# LOWER SNAKE RIVER
# LITTLE GOOSE AND LOWER GRANITE LOCKS AND DAMS

## Adult Fishway Systems
## Emergency Auxiliary Water Supply
## Phase II – Technical Report

### Final Report

| Appendix A | Quality Control Plan and Independent Technical Reviews (ITR) |

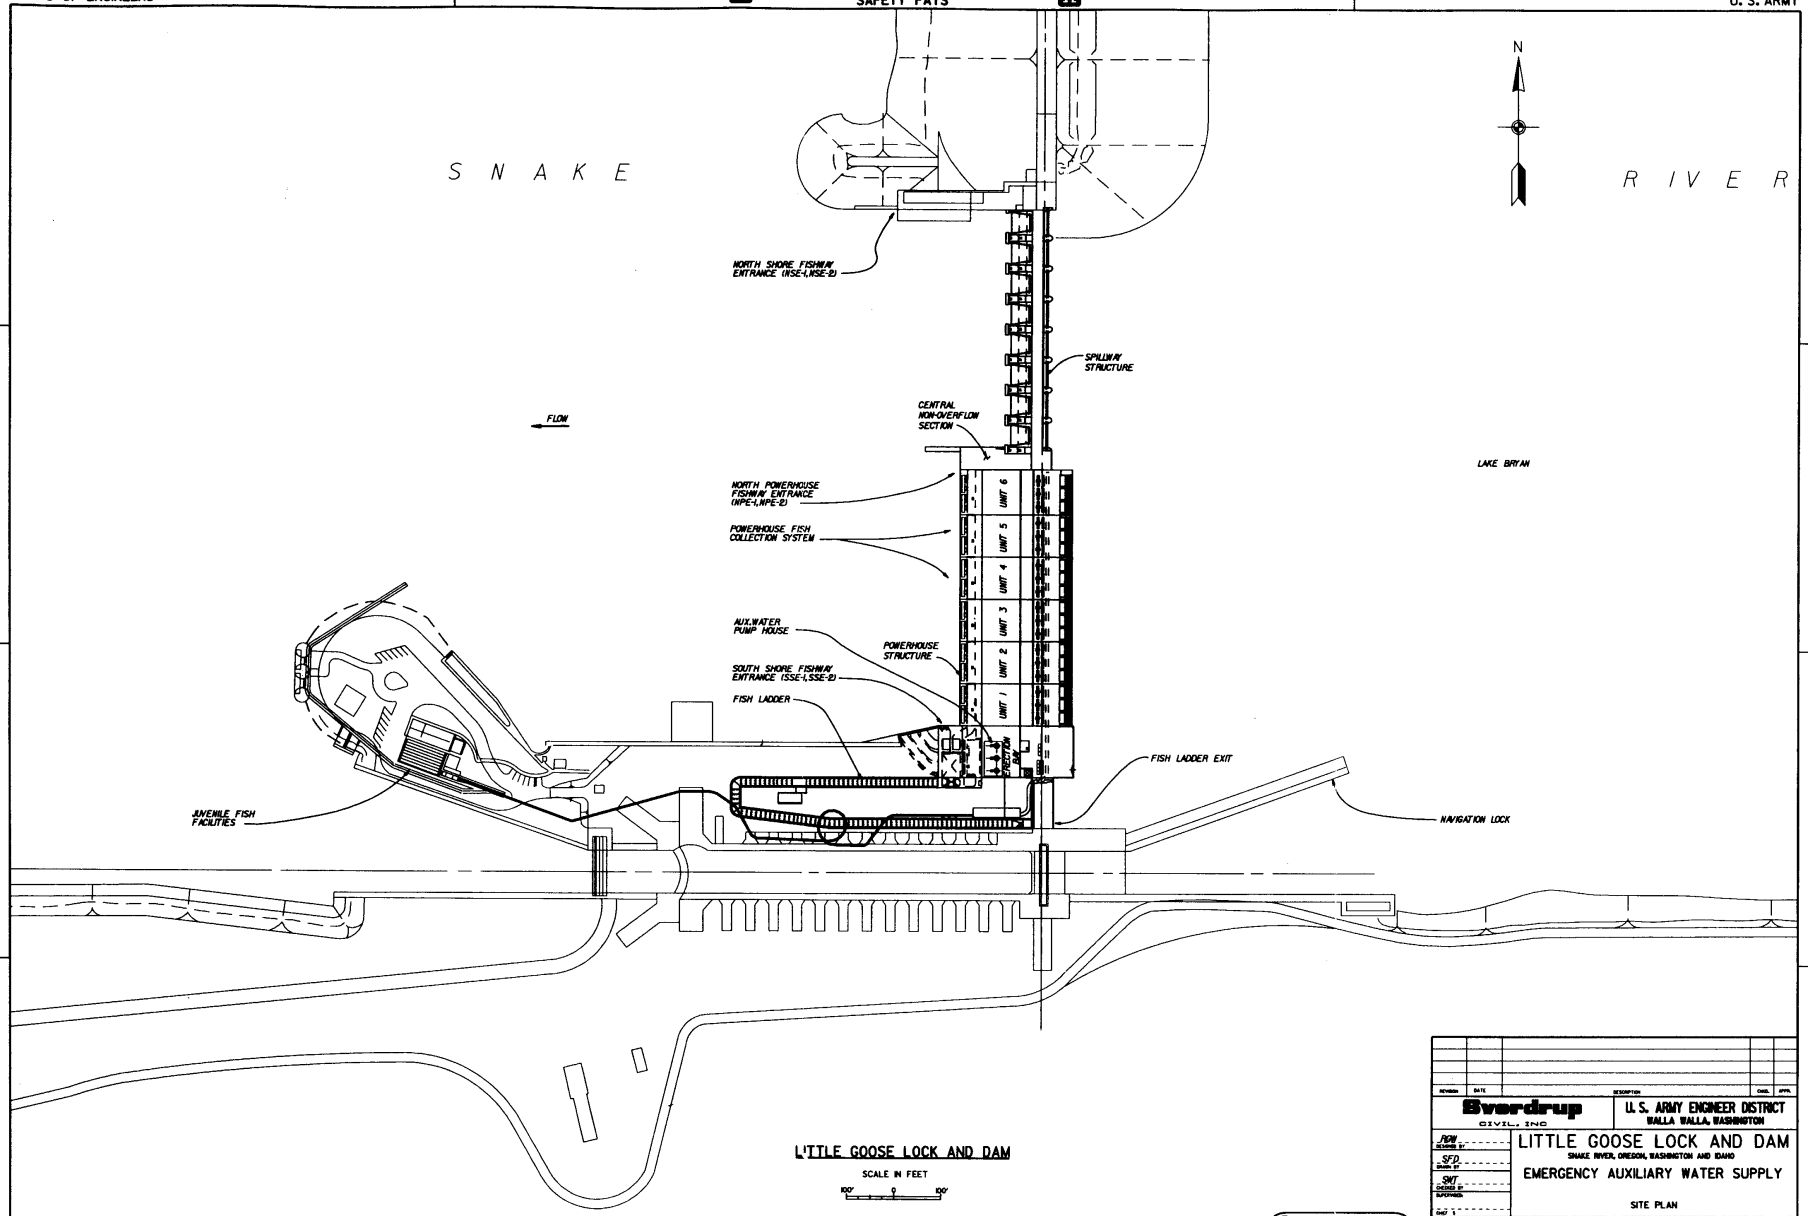
| Item No. | Drawing Sheet Spec. Paragraph | **COMMENTS** | Action taken on Comments by: Rolf Wielick | | |
|---|---|---|---|---|---|
| 9 | Plate 1.1.1 | Will butterfly valve be able to regulate properly given the number of bends in the line both upstream and downstream of the valve? | **A** – For butterfly valves, optimum location is 5 pipe diameters downstream of an elbow. This can be reduced if the orientation of the valve is adjusted to reflect the plane of the upstream elbow. There are about 5 pipe diameters upstream of the valve. No restrictions on downsstream bends, etc. are known. | **NA** | MRV |

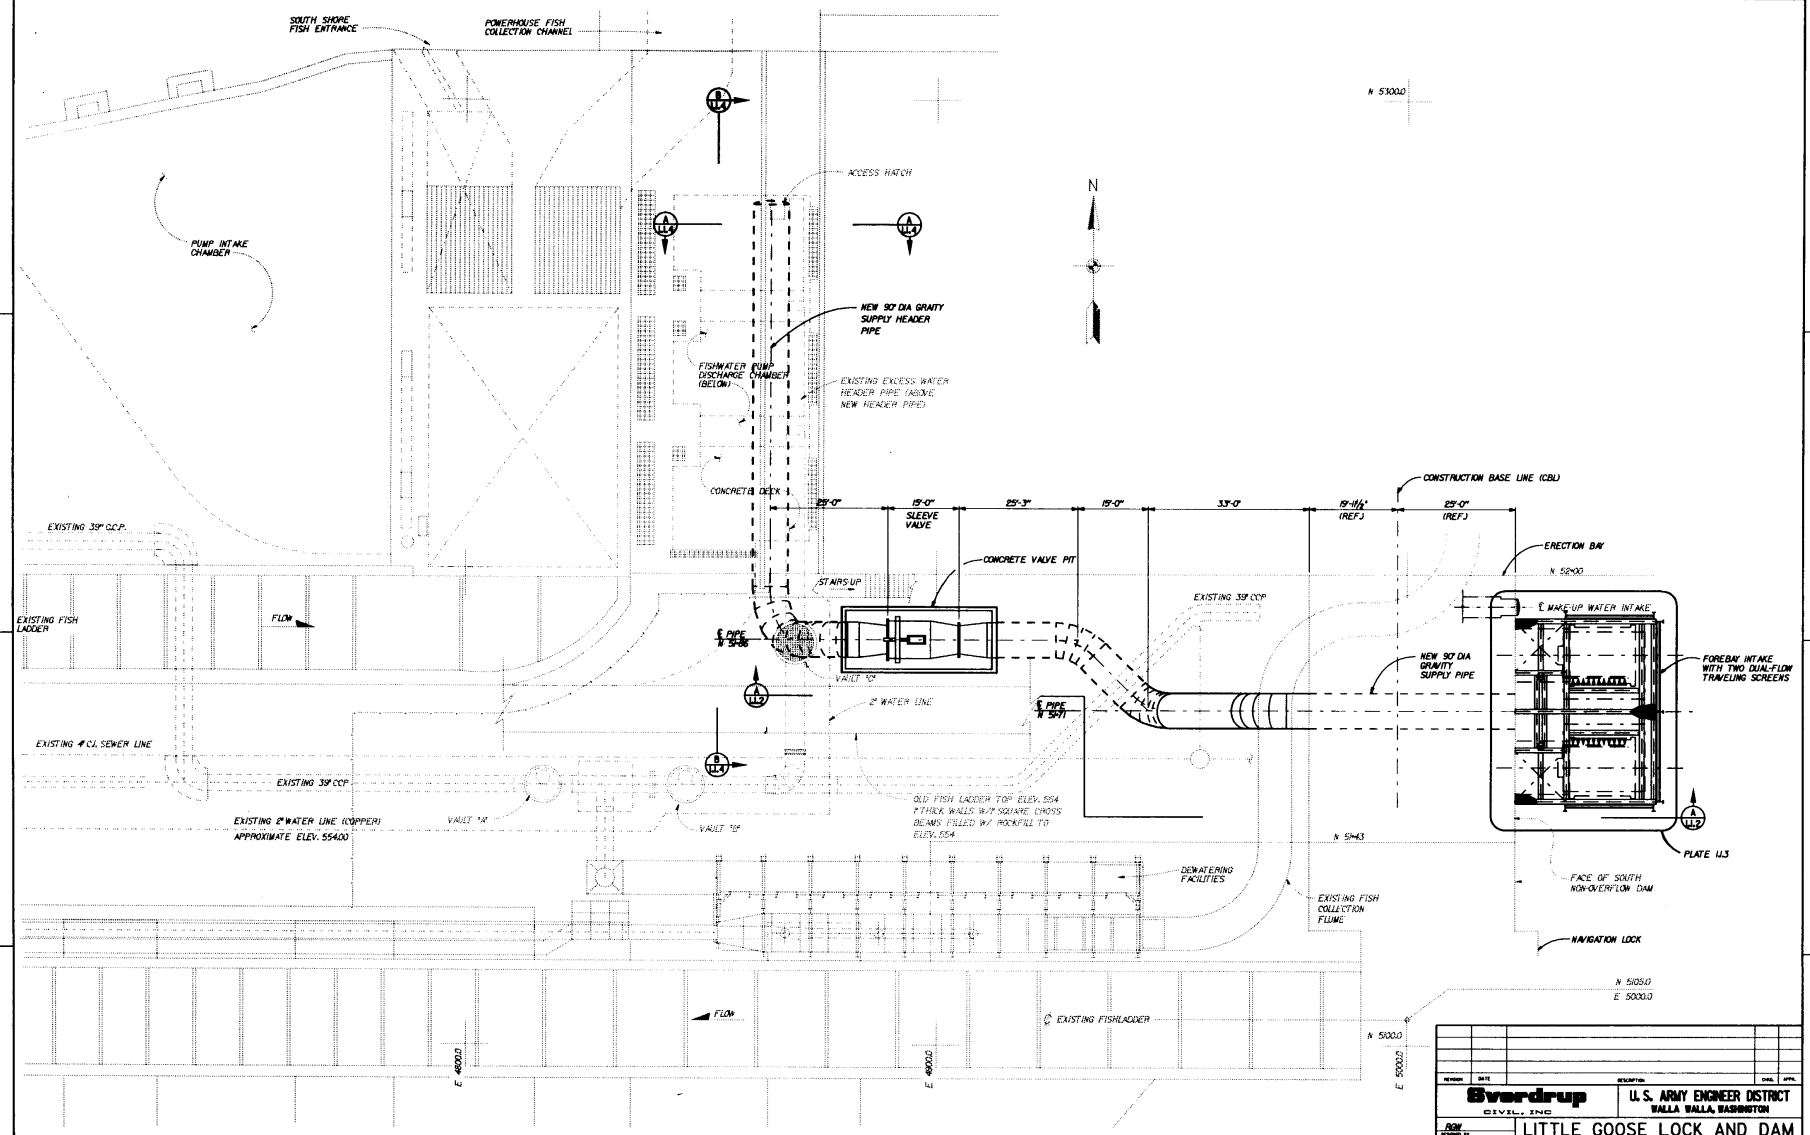
| Item No. | Dwg, Sht./Page/ Spec. Paragraph | **COMMENTS** | Action taken on Comments by: R. Wielick | | |
|---|---|---|---|---|---|
| 8 | Plate 1.1.2 | Where it leaves the south non-overflow downstream dam face, the 90" steel pipe could be turned down to vertical with a 90 degree bend and then sloped parallel to the dam toe with a 37 degree bend. This allows a simpler attachment to the dam face at two locations. The attachments can share the loads instead of concentrating them at the one at the base. Design, fabrication and installation of the supports, and maybe the pipe, should be easier. | **A** – I agree. We will review this and incorporate this change into the design if it checks out. | **C** | KBF |

| Item No. | Drawing Sheet Spec. Paragraph | COMMENTS | Action taken on Comments by: Rolf Wielick | | |
|---|---|---|---|---|---|
| 7 | Plate 1.1.2 | Additional thrust restraints appear to be necessary by either depiction or callout. | **A** – This will be reviewed. The pipe coming out of the dam is being revised to a vertical 90-degree elbow followed by a vertical 37-degree elbow to follow the slope of the toe of the dam. This will provide additional support. A restraint at the 90-degree elbow may still be required. Restraints below grade will be called out. Text notes that they would be required. | **C** | MRV |

| Item No. | Drawing Sheet Spec. Paragraph | **COMMENTS** | Action taken on Comments by: Rolf Wielick | | |
|---|---|---|---|---|---|
| 11 | Plate 1.1.2 | Additional pipe support(s) may be needed in the more or less vertical section of 90-inch diameter pipe. | **A** – See response to comment No. 7 | **NA** | MRV |

| Item No. | Dwg, Sht./Page/ Spec. Paragraph | **COMMENTS** | Action taken on Comments by: Rolf Wielick | | |
|---|---|---|---|---|---|
| 30 | Plate 1.1.2 | Access into the pipe is discussed in the text, but not depicted on the drawing. | **A** – Yes. | **NA** – Desribed in text but not shown on drawings | MRV |

| Item No. | Dwg, Sht./Page/ Spec. Paragraph | **COMMENTS** | Action taken on Comments by: Perry Johnson | | |
|---|---|---|---|---|---|
| 5 | Plate 1.1.2 | Installation of two combination air/vacuum valves appears to be sufficient for the length of the supply pipe. However, a waterhammer analysis should be done (if this option is pursued beyond the Phase II level) to verify system pressures during critical operating scenarios, such as closing or opening the flow control valve (72-inch sleeve valve) and the sluice gate. | **A** – Agree | **NA** | MR |

PLATE I.I.3

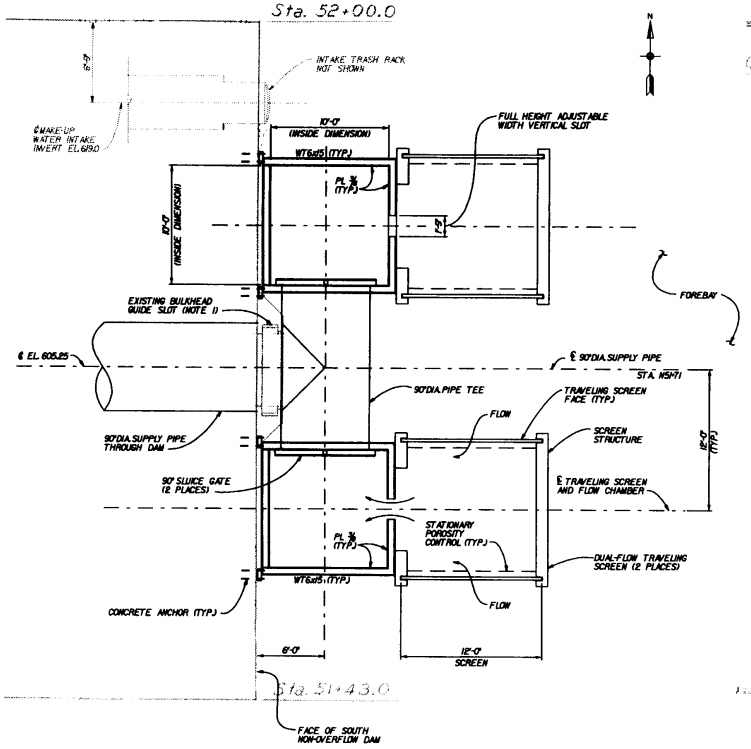
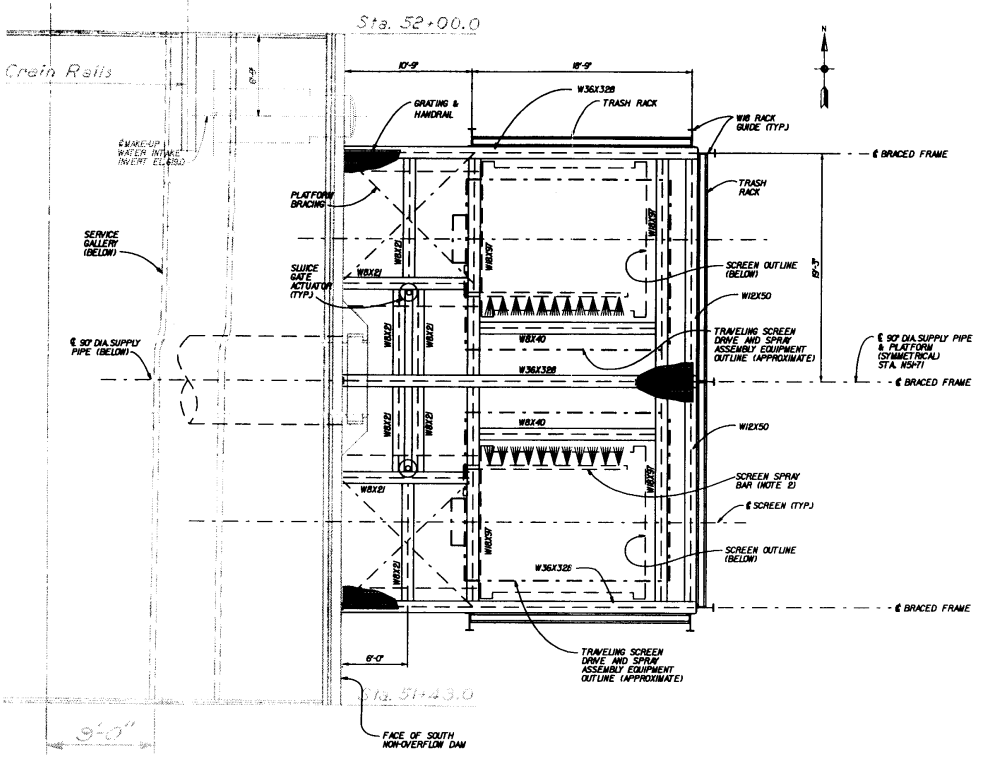
| Item No. | Dwg, Sht./Page/ Spec. Paragraph | **COMMENTS** | Action taken on Comments by: R. Wielick | | |
|---|---|---|---|---|---|
| 12 | Plate 1.1.3 | Plan – El. 651.0: Will the platform bracing and interior framing at the deck level need to be removable to allow access for maintaintance or replacement of the sluice gates? | **A** – Yes. This will be noted in the report. All deck framing is assumed to be bolted so removal of discrete steel members should be possible if plans are made for it. | **C** | KBF |

| Item No. | Drawing Sht. Spec. Para. | COMMENTS | Action taken on Comments by: Rolf Wielick | | |
|---|---|---|---|---|---|
| 3. | Plate 1.1.3 | What are the existing guides where the new gravity pipe is penetrating the dam used for? The drawing says it's an existing bulkhead guide. And note 1. Says to remove the guide where the pipe penetration is. Is the guide something that is going to be installed prior to the pipe and then removed? Or is it and existing guide that may be needed again in the future and will not be available? | **A** – The guides are no longer used. They were part of the temporary fish ladder which was used during construction of the dam. | | |

| Item No. | Drawing Sht. Spec. Para. | COMMENTS | | | |
|---|---|---|---|---|---|
| 30 | Plate 1.1.3 | Will there be any annunciation for screen plugging? There are no details on the screen guides, drive system, debris removal system, screen material, or screen panel mounting arrangement. The DDR does not contain any catalog information on this system. | **A** – The lack of annunciation was mentioned in the ITR, also. The text will be revised to note that. A copy of the vendor information on the screen will be added to the DDR in the cost estimates (typical costs). | | |

SHEET NO. PLATE 1.2.1

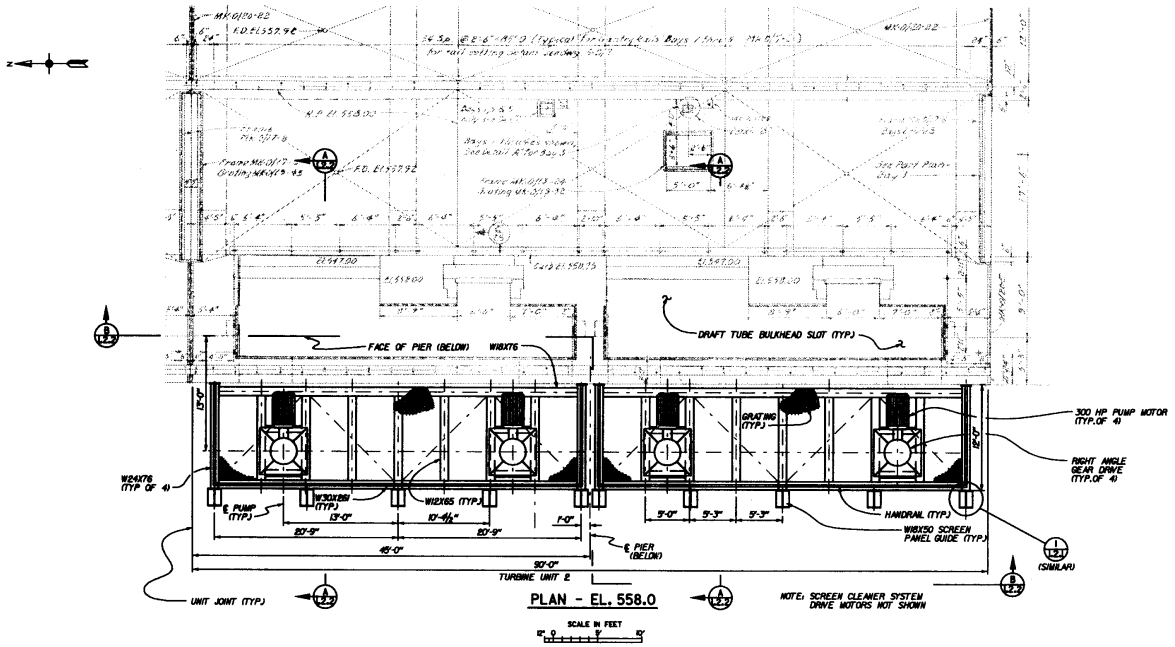
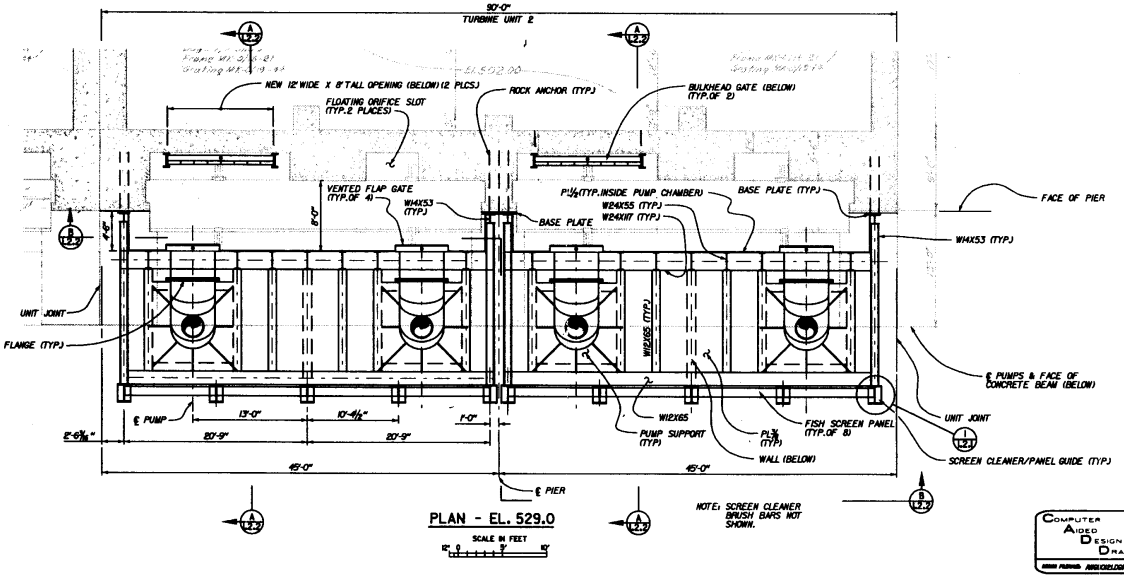
| Item No. | Dwg, Sht./Page/ Spec. Paragraph | **COMMENTS** | Action taken on Comments by: R. Wielick | | |
|---|---|---|---|---|---|
| 15 | Plate 1.2.1 | Plan – El. 512.0: The outer rock anchors at the center pier look a bit close to the edge of the draft tube bulkhead slot. Two columns of bolts may be all that can be fit in. | **A** – We will review this configuration and consider this comment. Final detailing of the connection is left for final design. | **C** | KBF |

PLATE I.2.2

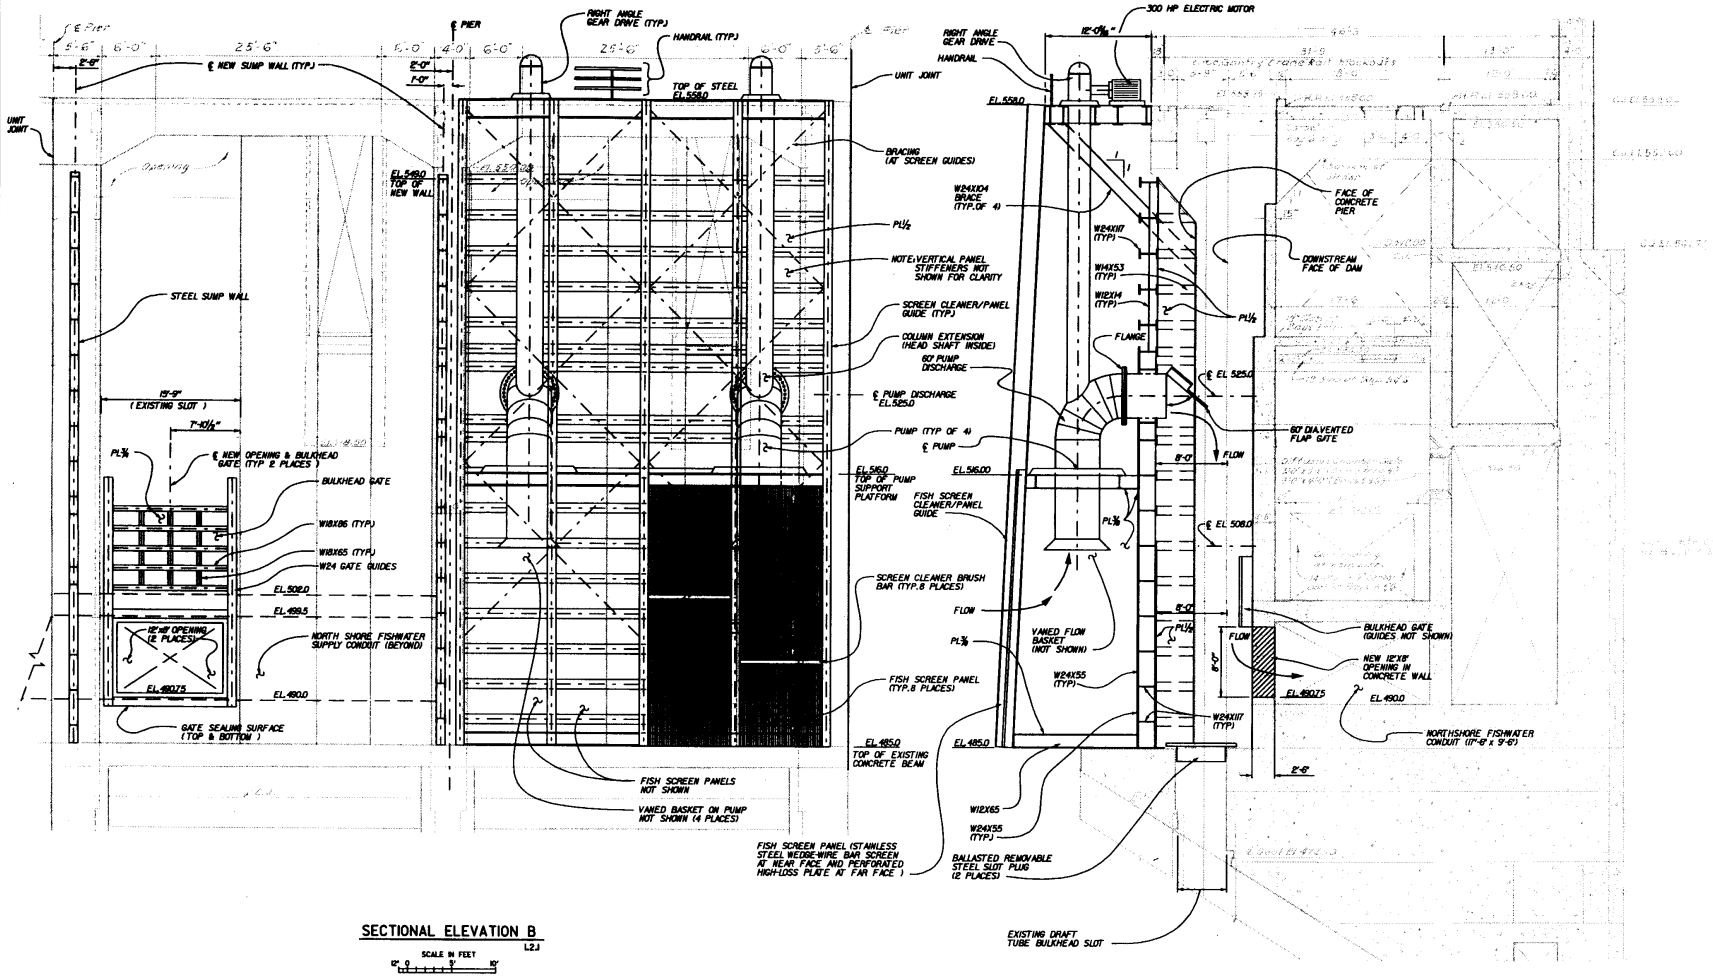
| Item No. | Dwg, Sht./Page/ Spec. Paragraph | **COMMENTS** | Action taken on Comments by: R. Wielick | | |
|---|---|---|---|---|---|
| 16 | Plate 1.2.2 | In report section 4.5.3.3.a, first paragraph, the removal of the pump components for maintenance is described. Extraction of the lower pumping unit by cranes may be greatly facilitated if the floor framing, supporting the pump and gearbox at the deck level, were removable to allow a vertical lift. | **A** – That was the intent. The report text will be revised to describe this procedure. The deck framing is assumed to be bolted. Temporary removal of discrete beams should be assumed for removal of the pump. | **C** | KBF |
| 17 | Plate 1.2.2 | In report section 4.5.3.4.b, first paragraph, installation of each pump structure as a single piece is described. Section A of Plate 1.2.2 should depict more specific structural continuity, between the deck level support and the lower structure, if the structure is to be transported and installed as a unit. | **A** – I think that your Comment No. 7 is valid. The text will be revised to indicate that construction installation would be accomplished with components bolted together at the site. | **C** | KBF |

| Item No. | Drawing Sht. Spec. Para. | COMMENTS | | | |
|---|---|---|---|---|---|
| 4. | Plate 1.2.2 | 1.It looks like it may be difficult to get the draft tube bulkheads in the slots behind the pumps. Is their adequate clearance?<br>2. How does the steel plug in the bulkhead slot get removed if a bulkhead needs to be installed?<br>3. How is the steel structure protected from corrosion? | **A** - The design is intended to provide a clear path for bulkheads, roughly defined by the width of the slot opening in the concrete roof of the draft tube discharge. This should be possible with the configuration shown. Note that the flap gate which appears to protrude into this space would not protrude during the installation/removal of the bulkheads. The same mechanism/system that is used to retrieve the bulkheads (lifting beam on the crane and lifting eyes on the equipment) would be used. Should work the same way. Corrosion protection could be the COE's heavy duty paint system or a metalized coating system. Impressed current systems don't seem to be very successful over the long term. | | |

| Item No. | Drawing Sht. Spec. Para. | COMMENTS | Action taken on Comments by: Rolf Wielick, Perry Johnson, Gerald Walker, and Dave Absher | | |
|---|---|---|---|---|---|
| 36 | 4-34, 4-40<br>Plate 1.2.2 | Very little detail was given as to how the screen cleaners and screen panels could be removed. The plate does not seem to show provisions for this. Page 4-34 says the "entire mechanical system for the cleaners" can be removed, page 4-40 says "the cleaner drive mechanism will require diver inspection". These seem to be contradictory. Suggest moving the screen cleaner drive machinery to the top of the structure so it is out of the water. Also, commercial screen cleaners for this type of screen may also be available. | **A** – The drawings (Plate 1.2.1 and 1.2.2) don't show a removable cleaner drive system. A removable screen panel system is shown in Detail 1 on Plate 1.2.1. The text will be revised to make the two consistent. Suffice to say that in the final design of this | | |
